**Re: EOLM C&DD Landfill  
Director's Final Findings and Orders (DFFO)  
DFFO  
Construction & Demolition Debris  
Allen County  
CDDL018889**

Re: EOLM-Lima Allen County Landfill, Inc.  
C&DD Landfill  
NWDO Comments on  
EOLM's August 2018 Compliance Plan  
Comment Response Letter

**EOLM-LIMA ALLEN COUNTY LANDFILL, INC.  
COMPLIANCE PLAN**

**CONSTRUCTION AND DEMOLITION  
DEBRIS LANDFILL  
ALLEN COUNTY, OHIO  
FACILITY COMPLIANCE PLAN  
(FINAL DESIGN, SEPTEMBER 2018)**

SCALE:	1" = 100'
SHEET NO.	6
OF	16

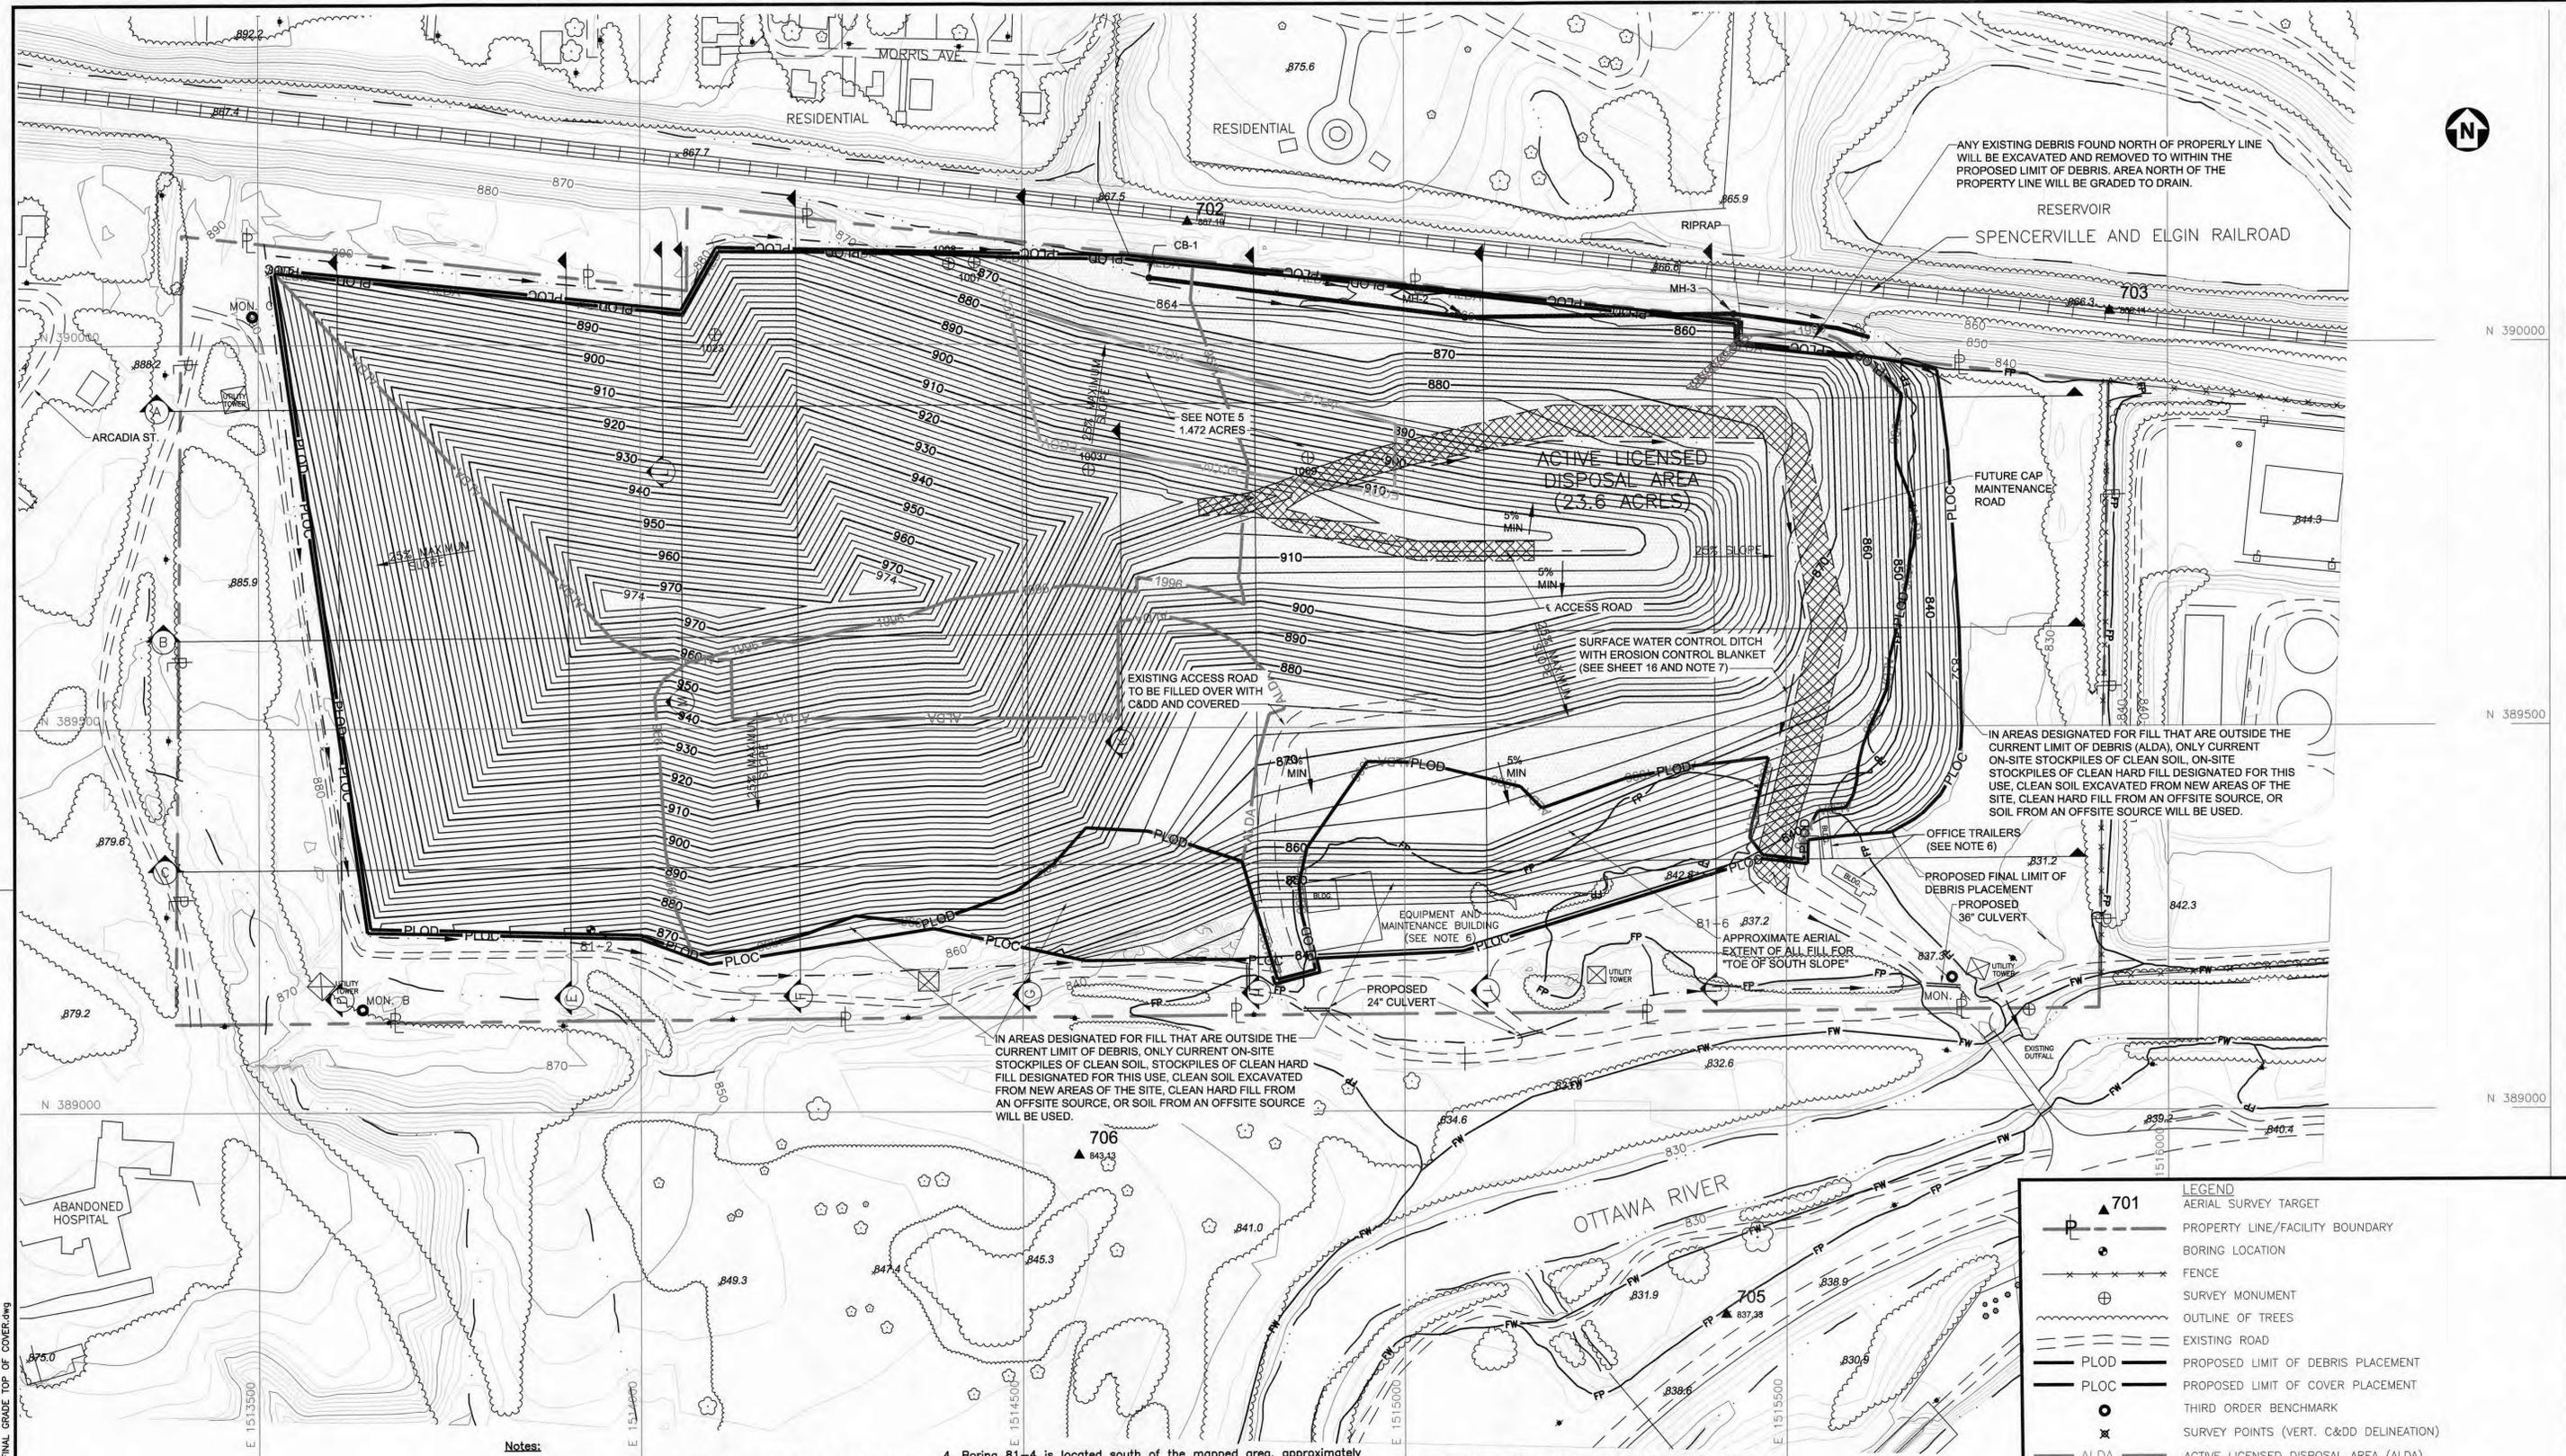
- 6.) *Final grade on Sheet 6, are not continuous between sections G and H along the southern and central portions of the landfill.*

**Response:** In the area referenced, proposed final grade contours meet existing grade inside the PLOC, where bold contours meet light contours. For clarity, proposed contours have been extended to the PLOC around the perimeter of the landfill.
